The City of Spartanburg Design Review Board

AGENDA

September 2, 2025, at 5:30 P.M.

Meeting Minutes of the Design Review Board (DRB)
Tuesday, August 5, 2025, at 5:30 PM
Dr. TK Gregg Recreation Center

Ballroom Elevation – Previously Approved

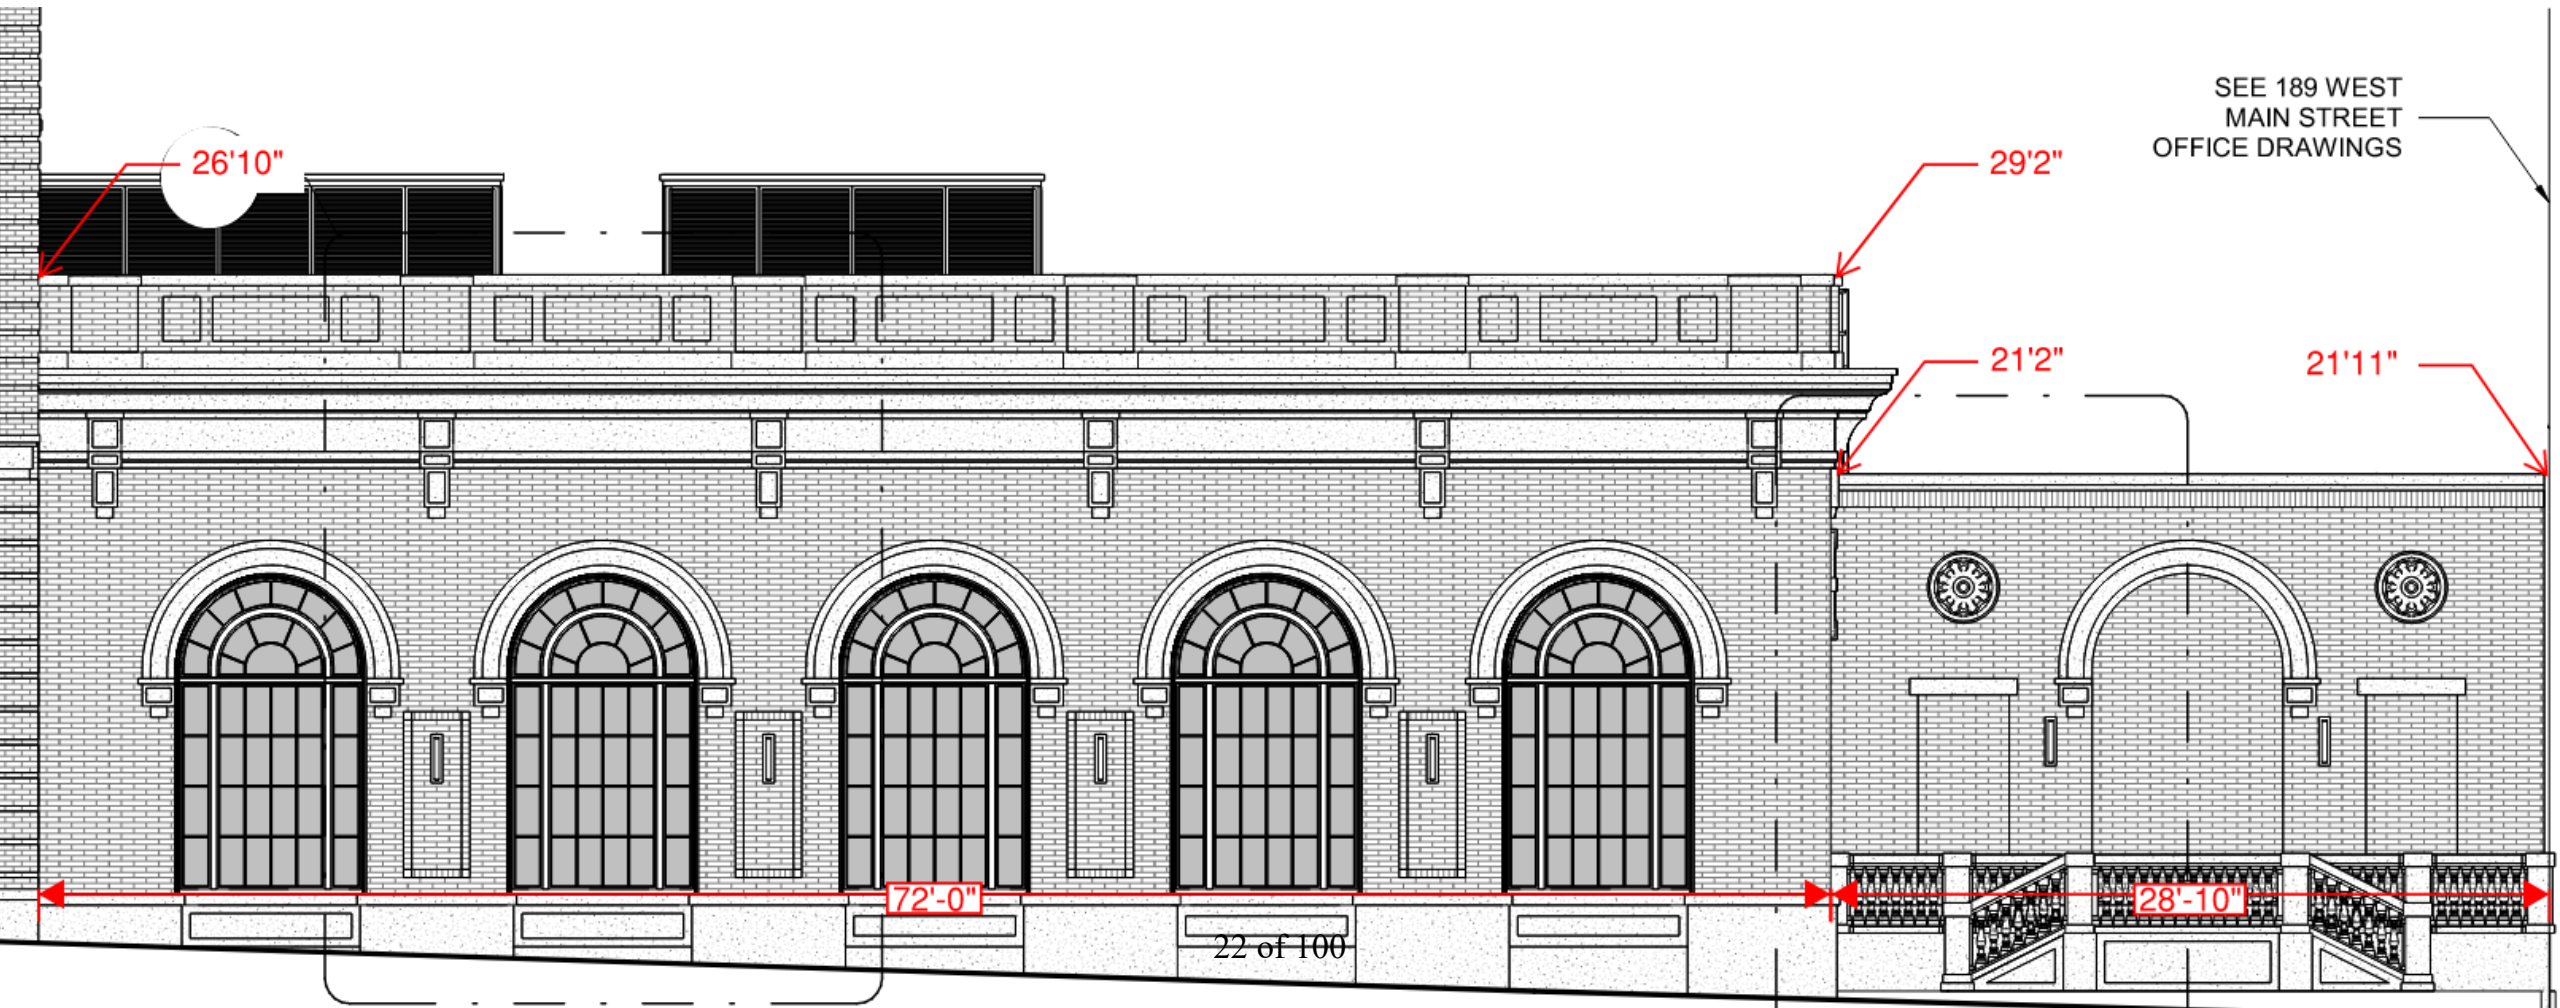
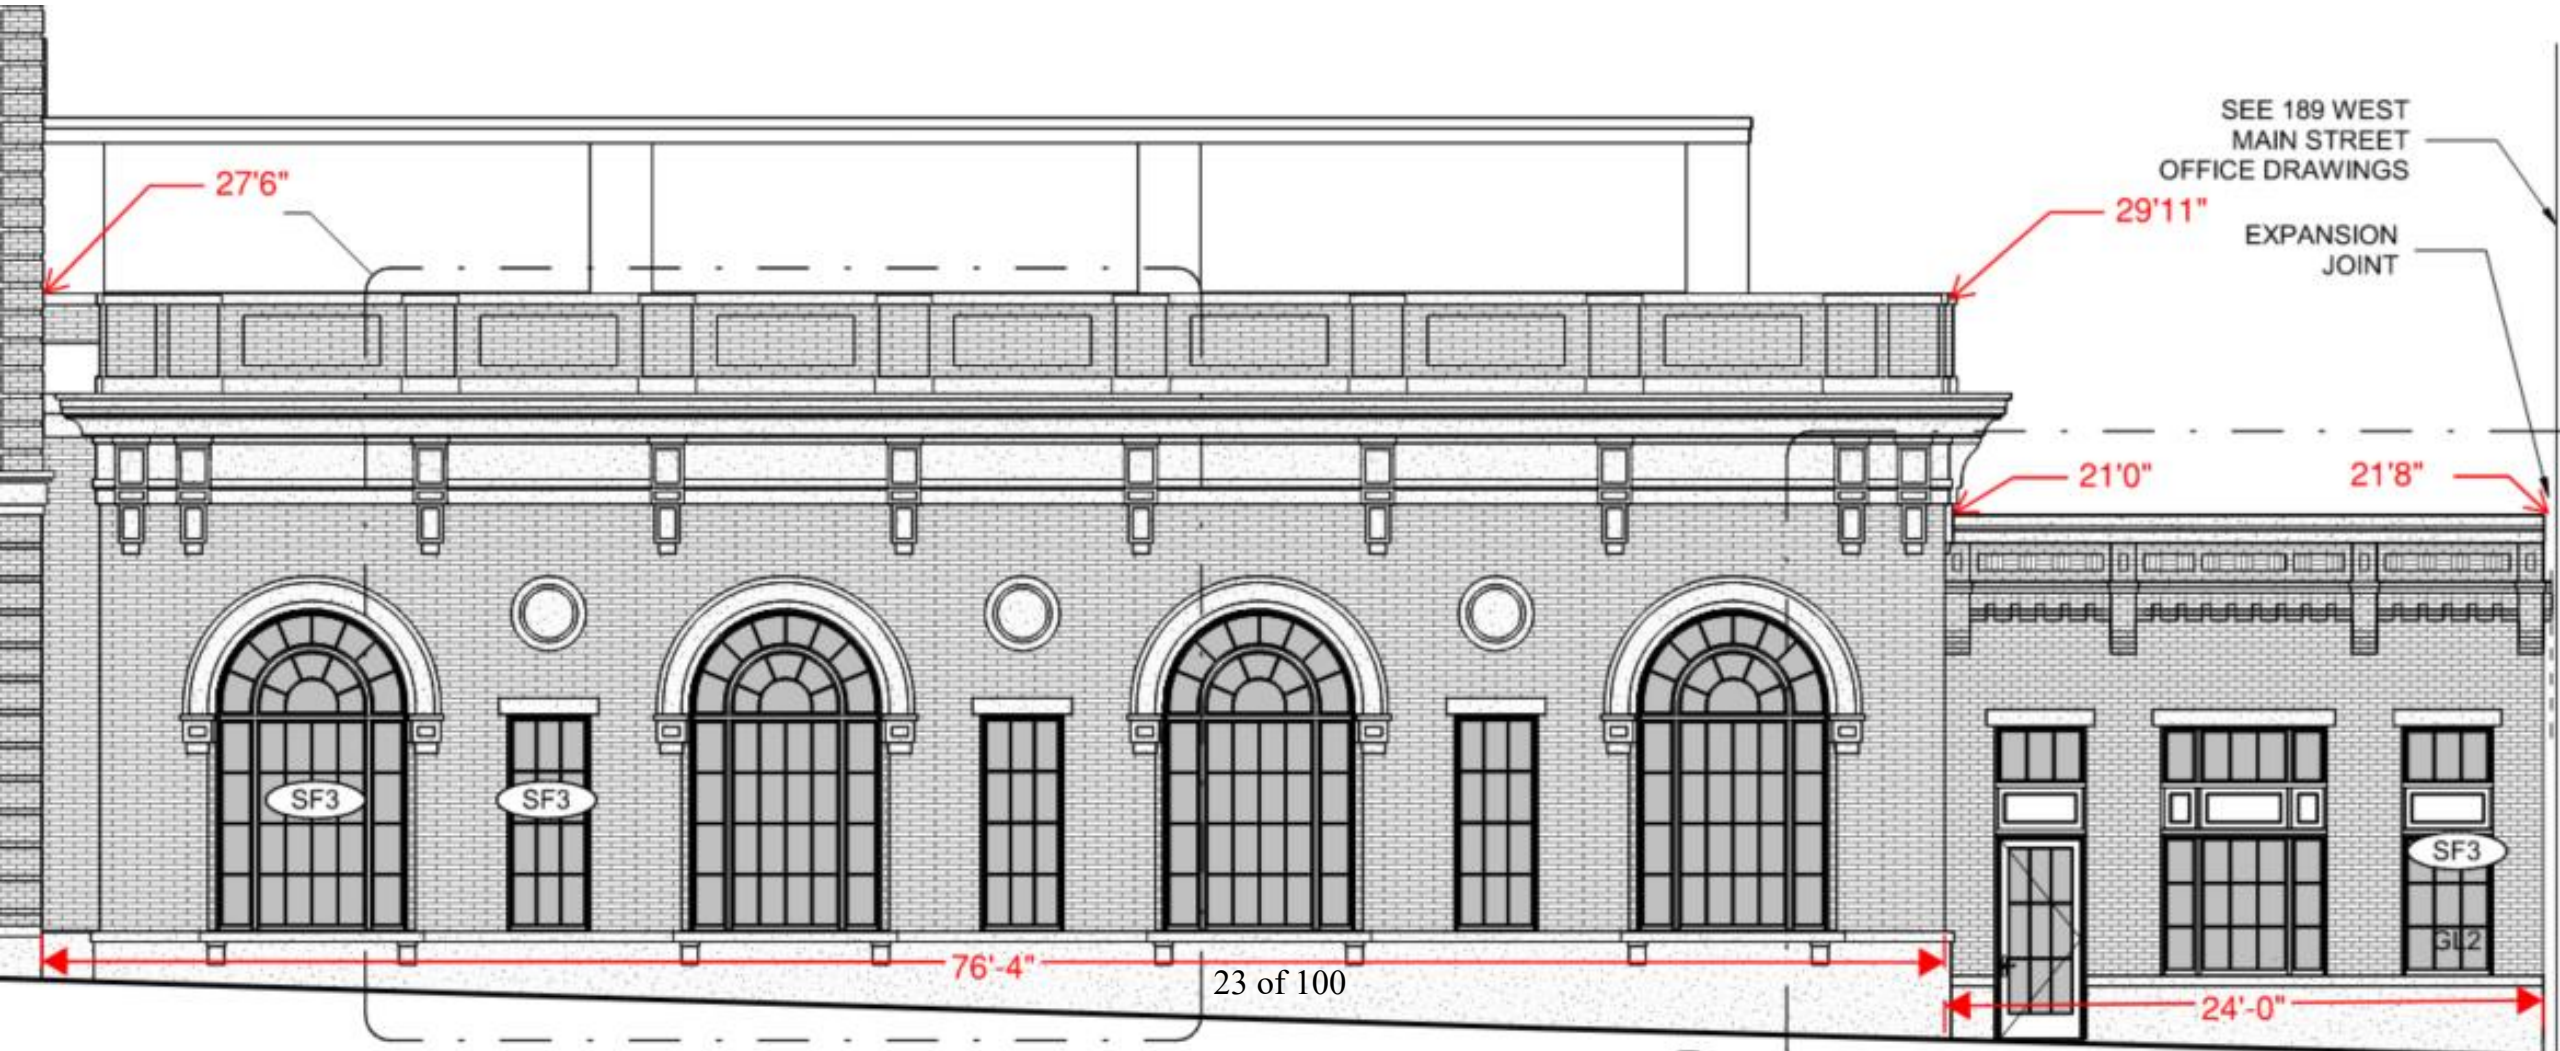
The revised façade design removes the previously elevated ballroom terrace, which was seen as a feature that helped articulate the façade and had the potential to activate the street.

- OTO Development is planning to expand the ballroom to account for operational concerns such as accommodating a catering kitchen, storage, and service corridor. This results in growing the ballroom West and South. The exterior alterations to the design include removal of exterior patio and revised façade to the one-story ballroom fronting Main Street.
- In January 2025, OTO presented the ballroom associated with the hotel as a single story and was approved by Spartanburg's Design Review Board. OTO Development is requesting an amendment to the previously approved variance to 3.3.4a, building height in DT-6.
